City of Portland, Maine – Building or Use Permit Application 389 Congress Street, 04101, Tel: (207) 874-8703, FAX: 874-8716

Location of Construction: 6 Hemlock St		Owner: Friedrich, Robert		Phone: 871-0240		Permit No: 971031	
Owner Address: 28 Church St Gorham, ME 04038		Lessee/Buyer's Name:		Phone:		BusinessName:	
Contractor Name:		Address:		Phone:		<div style="border: 2px solid black; padding: 5px; text-align: center;"> PERMIT ISSUED SEP 24 1997 CITY OF PORTLAND </div>	
Past Use: 1-fam		Proposed Use: Same		COST OF WORK: \$ 500.00		PERMIT FEE: \$ 25.00	
Proposed Project Description: Remove existing porch & stairs & doorway/Board-Up Erect Stairs - Different Location				<input type="checkbox"/> Approved <input type="checkbox"/> Denied		INSPECTION: Use Group: R3 Type: 5B Signature: <i>[Signature]</i>	
				Signature: _____ Date: _____		Zone: R-6 CBL: 065-B-007	
				Action: <input type="checkbox"/> Approved <input type="checkbox"/> Approved with Conditions <input type="checkbox"/> Denied		Zoning Approval: <i>[Signature]</i> 9/23/97 Special Zone or Reviews: <input type="checkbox"/> Shoreland <input type="checkbox"/> Wetland <input type="checkbox"/> Flood Zone <input type="checkbox"/> S

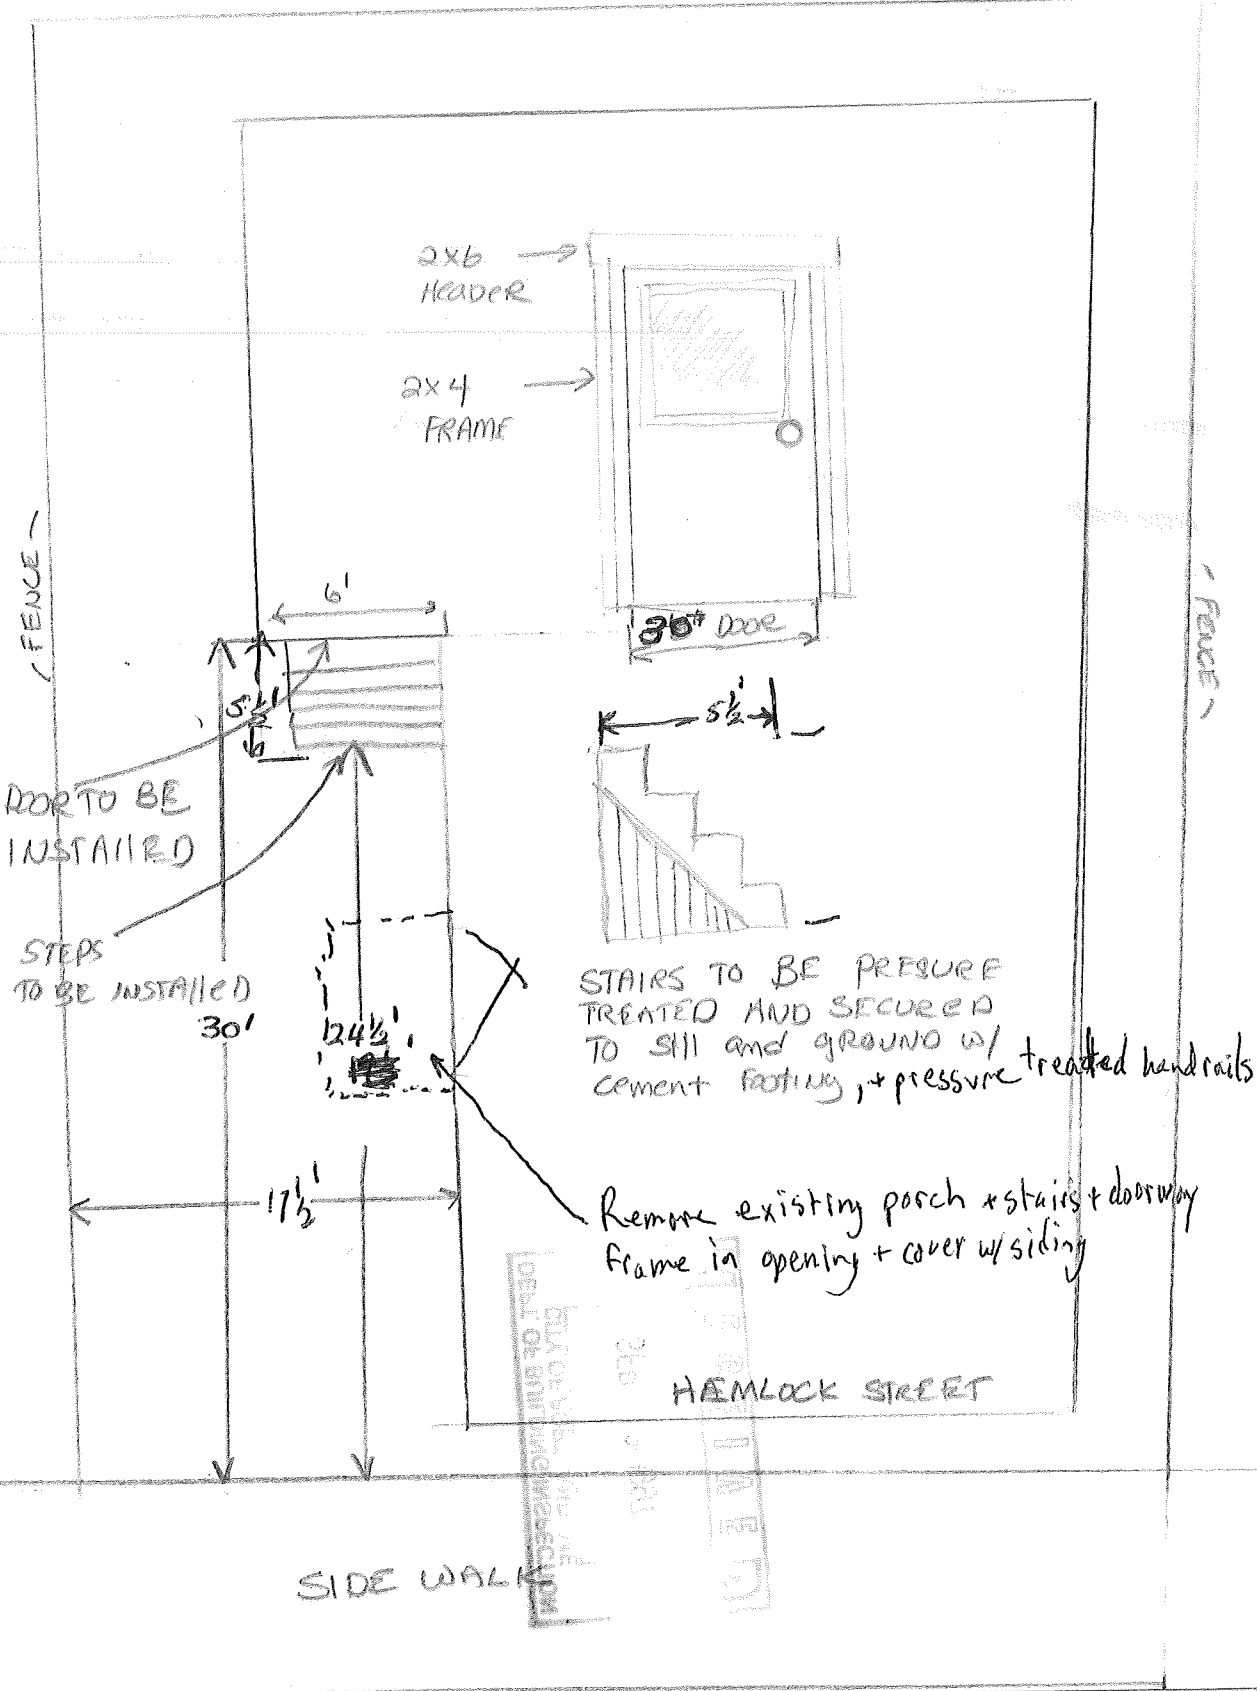
2) On 9/23/97 I re-inspected 6 Hemlock Street per request of the owner. He has recently removed a small addition in order to allow more room for potential parking. He told me that the wooden fence is the lot line. I measured 15 feet from the wooden fence to the building. That would allow for a 9'x19' parking space along with a 5 foot setback. I would now say that he could meet the land use ordinances as far as setbacks if you allowed a curb cut.

DOOR TO BE INSTALLED

STEPS TO BE INSTALLED 30'

STAIRS TO BE PRESSURE TREATED AND SECURED TO SILL AND GROUND w/ cement footing, + pressure treated handrails

Remove existing porch + stairs + doorway frame in opening + cover w/ siding
